# Conceptual Review Agenda

Schedule for 09/09/13 to 09/09/13

**Re:** 405 Linden - Change of Use

**Re:** Ladymoon Dr & Precision Dr - Office

**SITE PLAN**

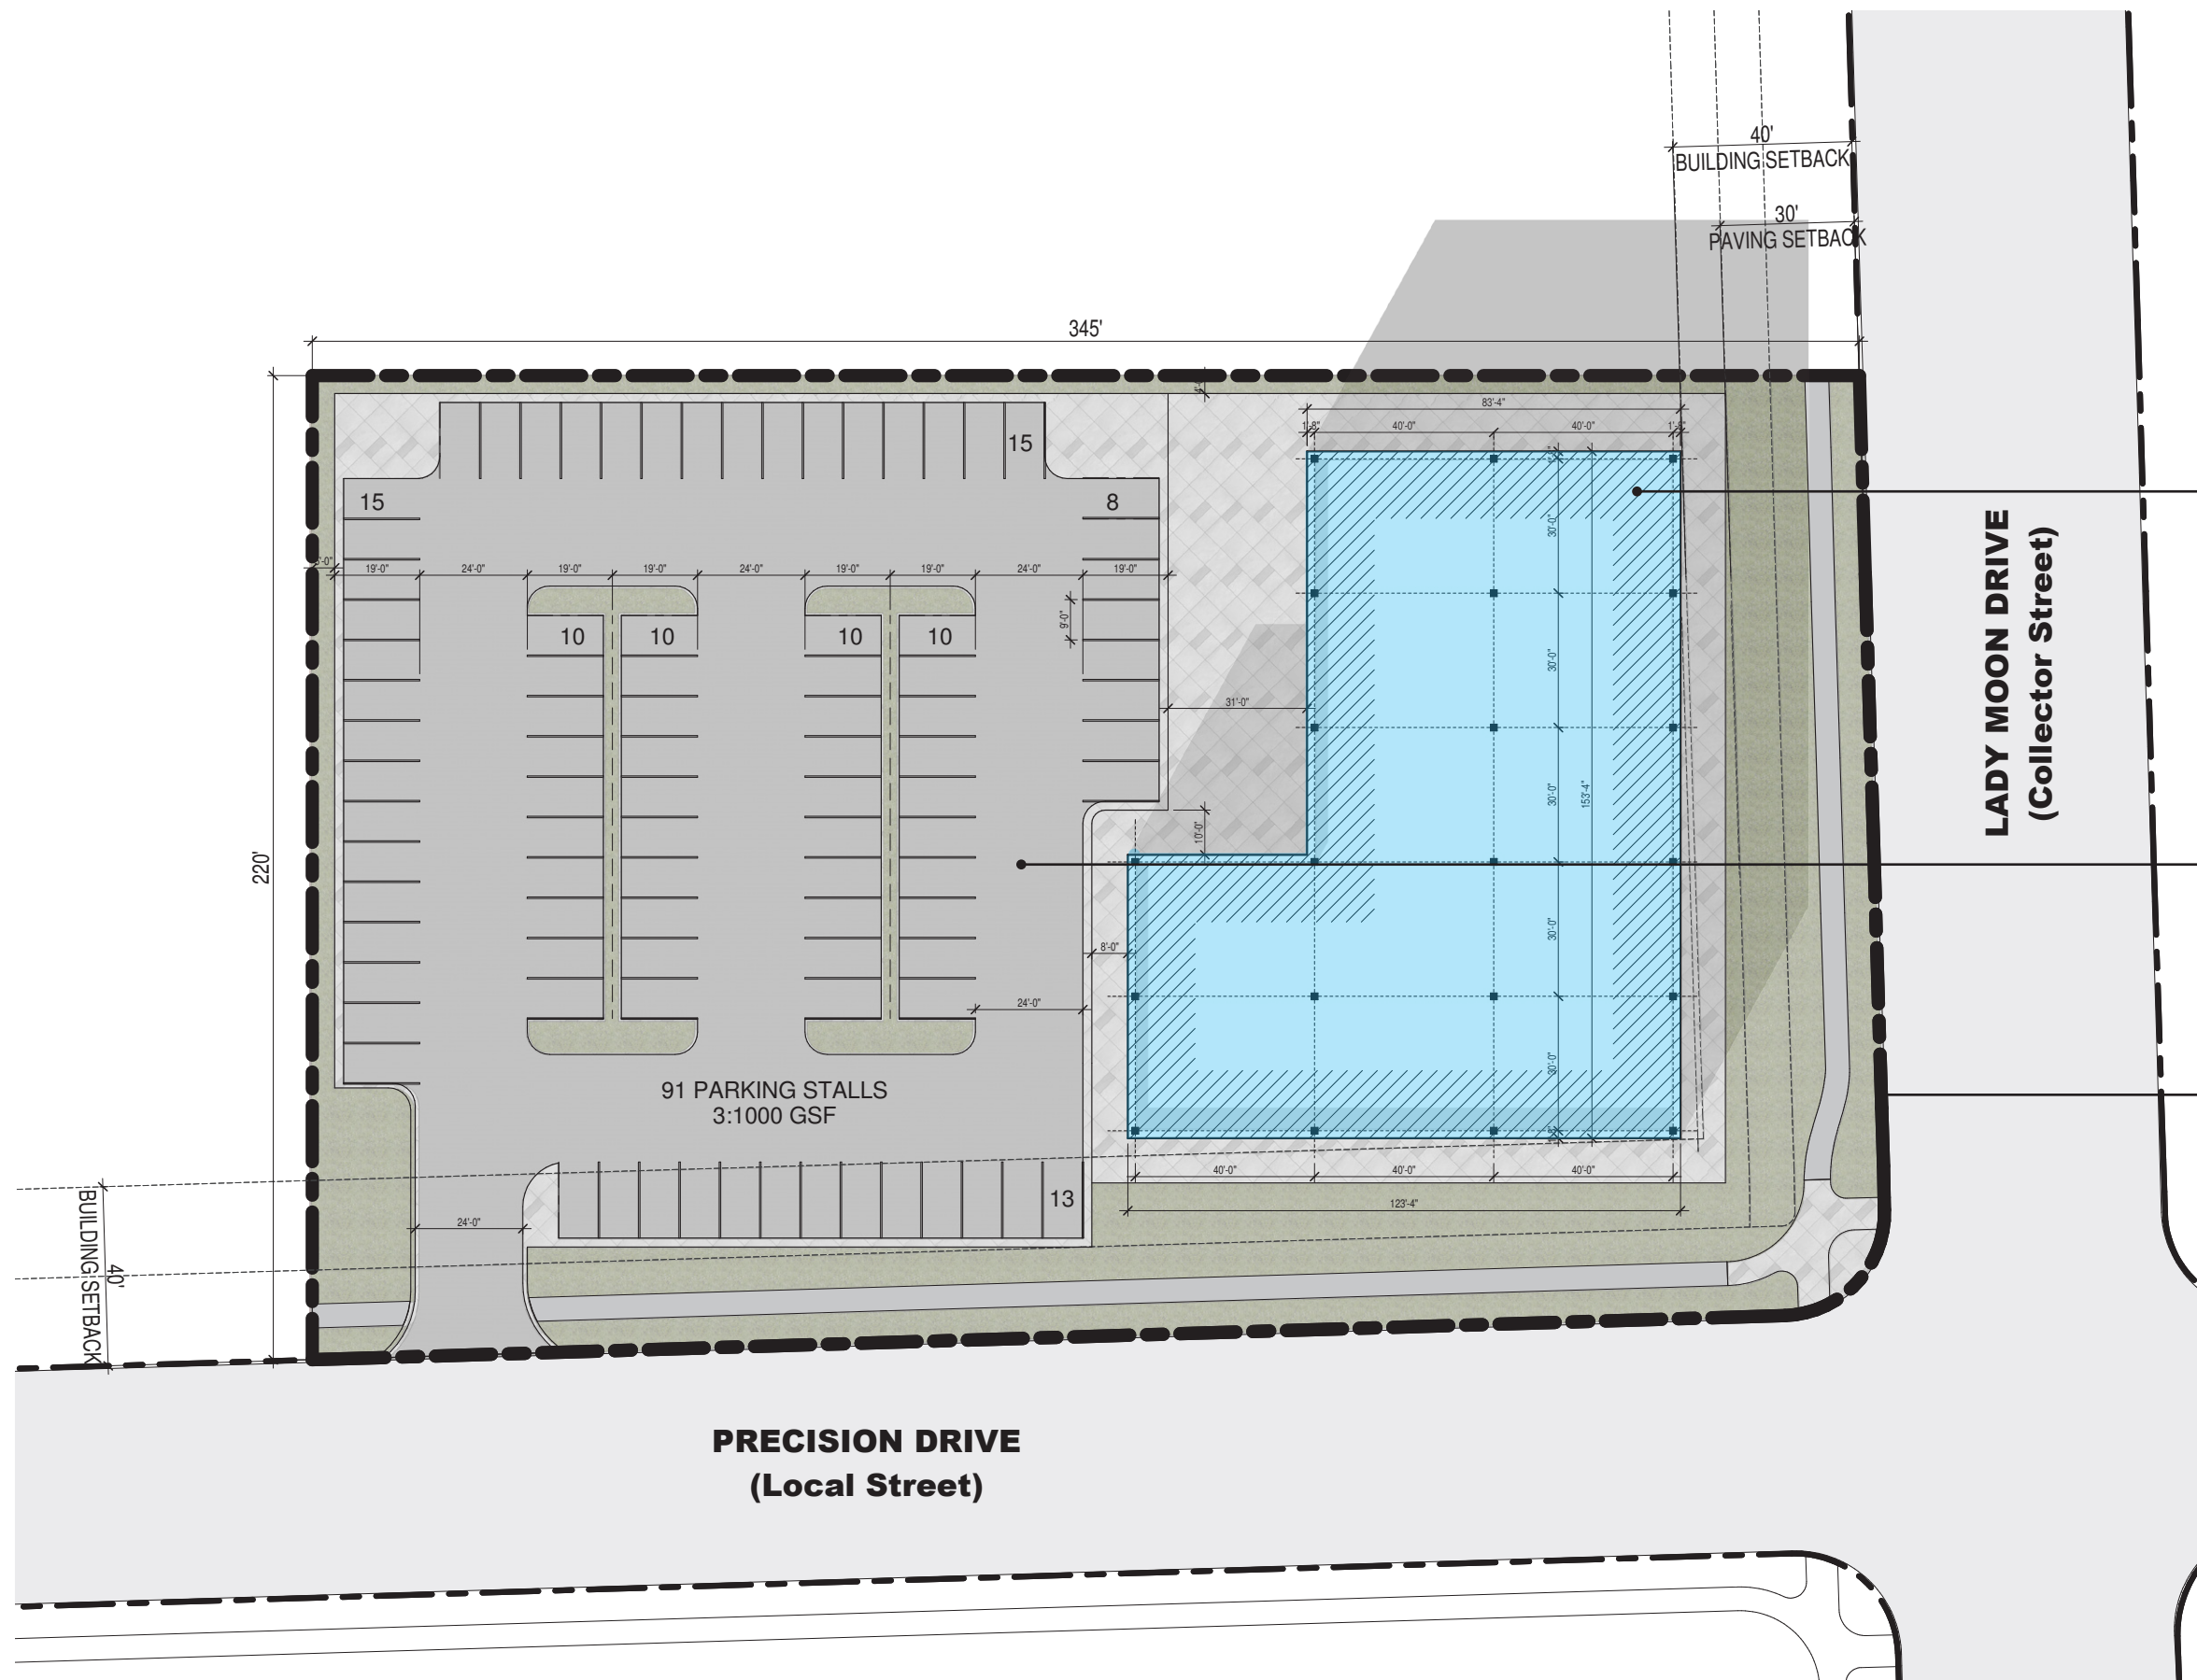
1. A minimum of 4 HC parking stalls required.
2. A minimum 5' wide landscape strip is required along the north lot line adjacent to the parking lot. The site plan shows a dimension of 4'.

PROJECT LOCATION:  
 DRAWING: CONCEPTUAL UTILITY PLAN EXHIBIT

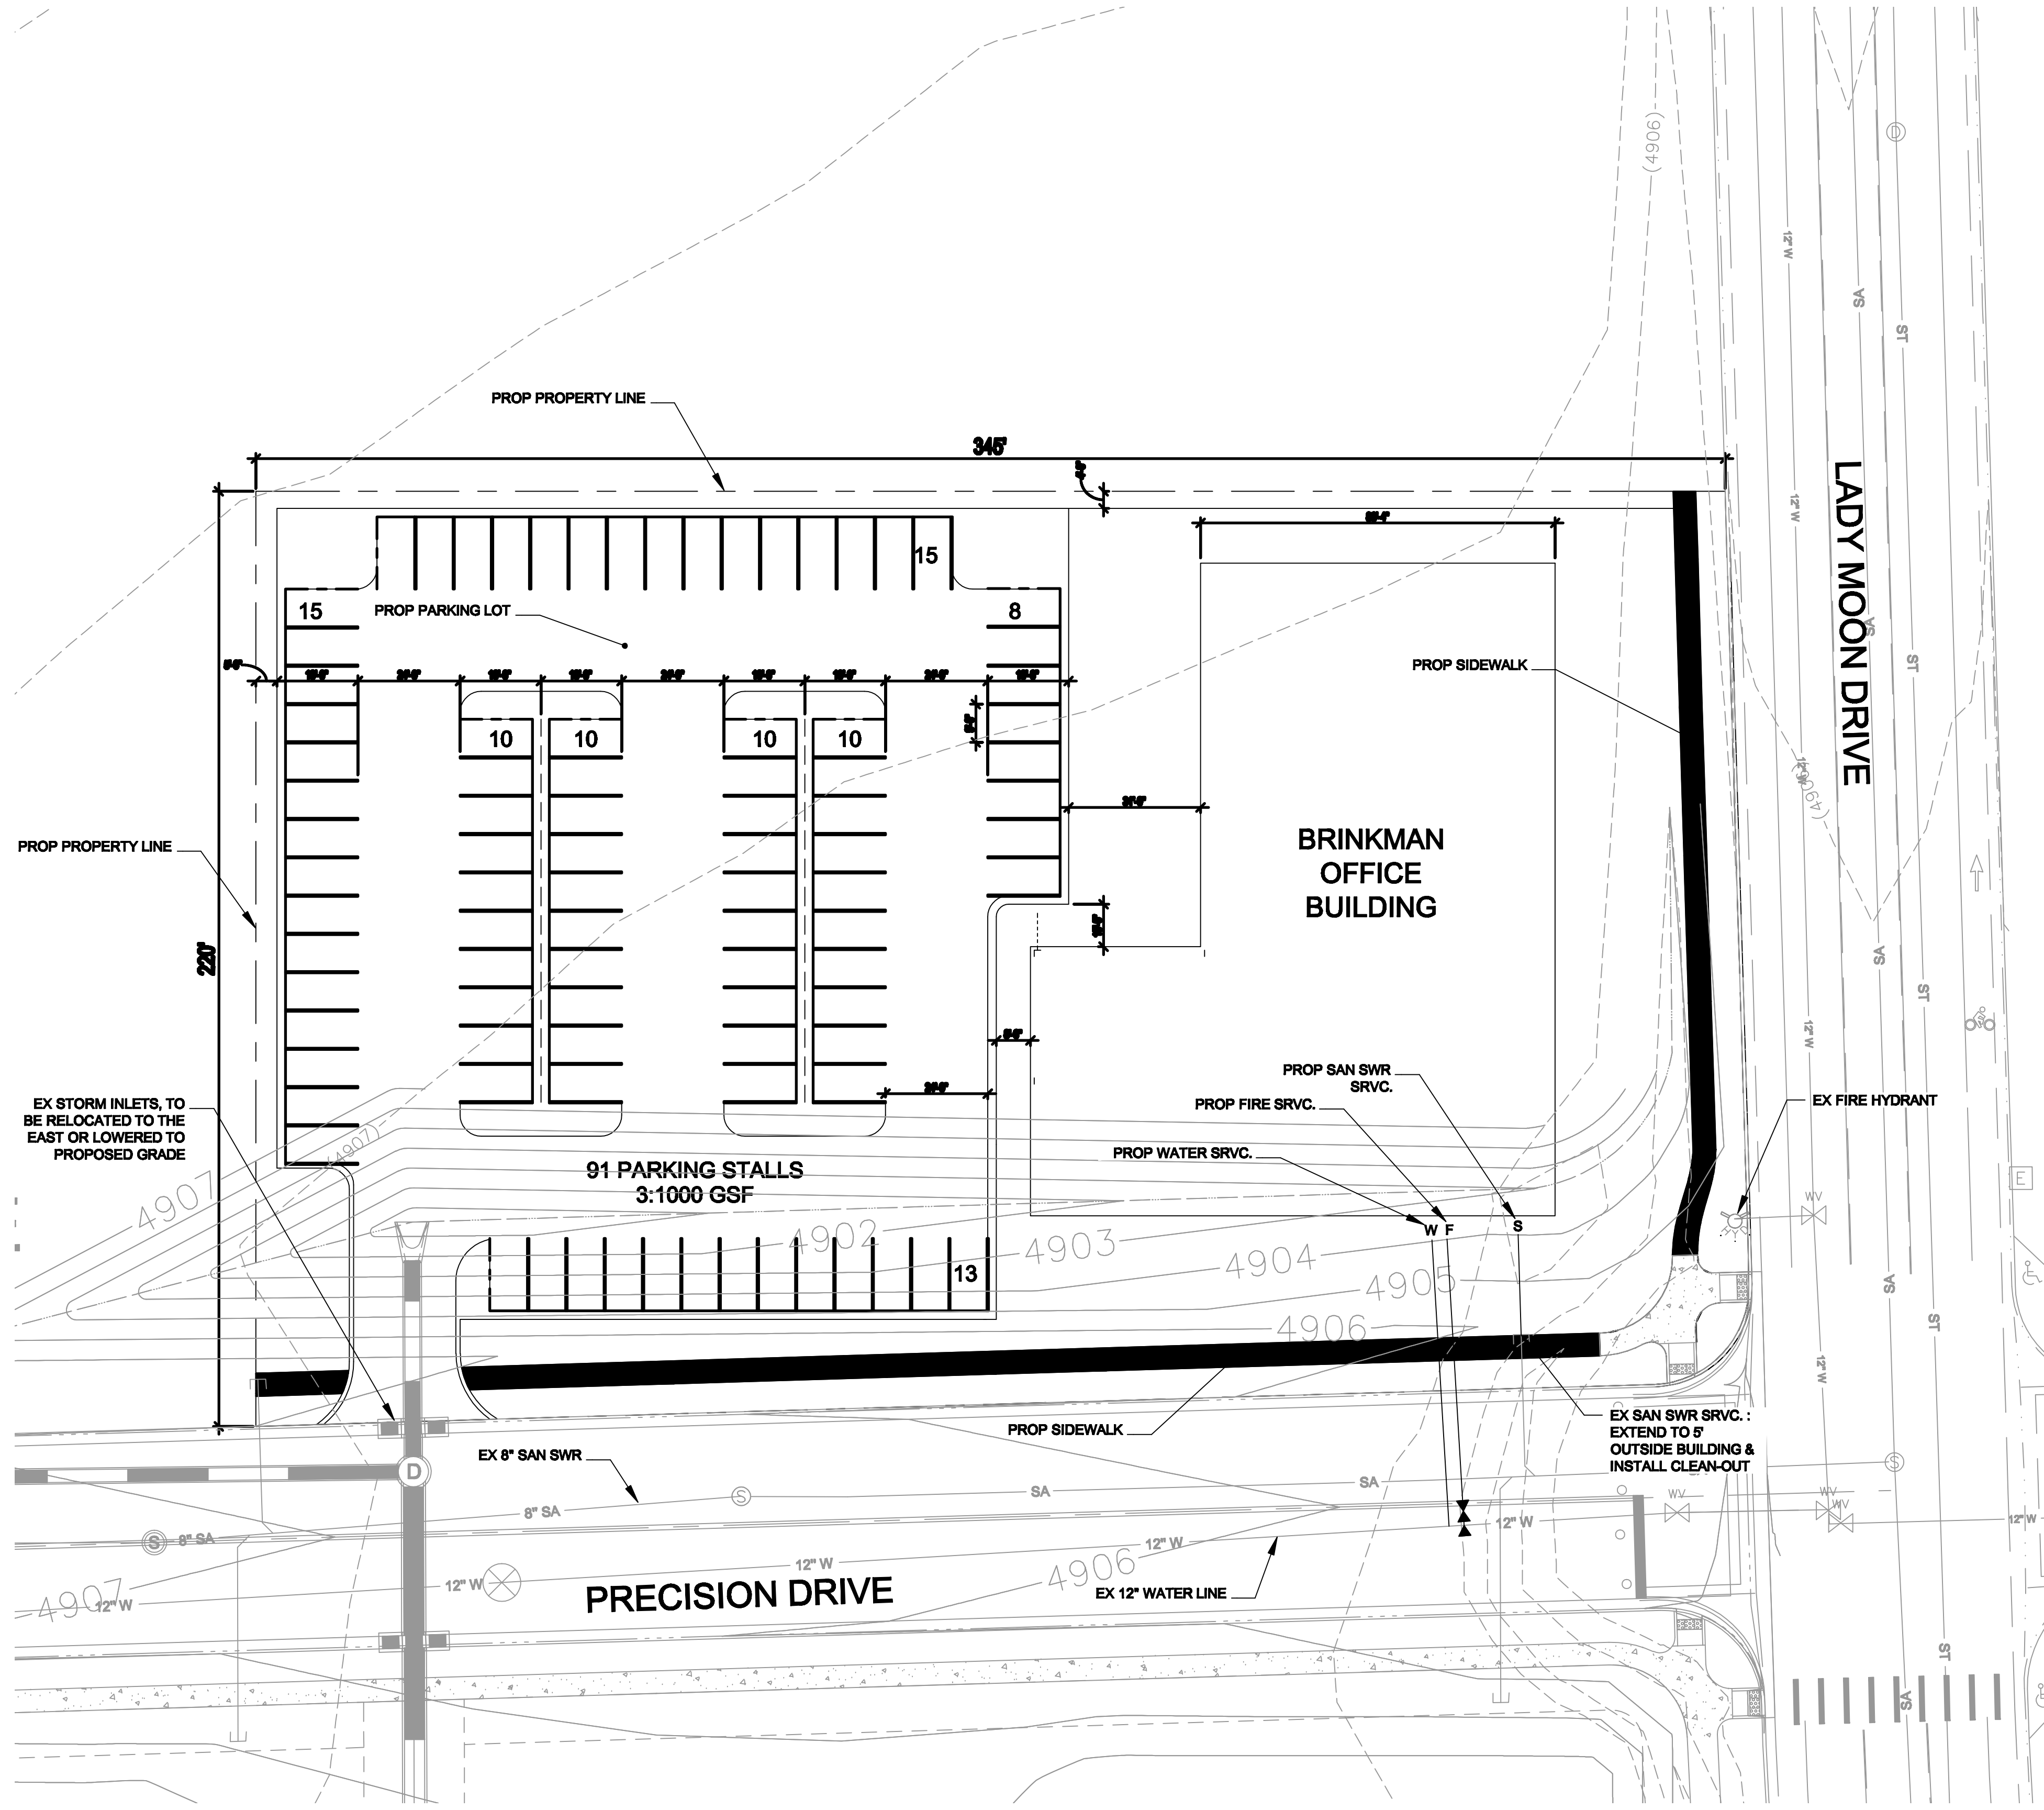
1. The existing City water mains adjacent to the site include 12-inch water mains in both Precision and Lady Moon.
2. Wastewater service in this area is provided by the South Fort Collins Sanitation District.
3. The water conservation standards for landscape and irrigation will apply. Information on these requirements can be found at: <http://www.fcgov.com/standards>
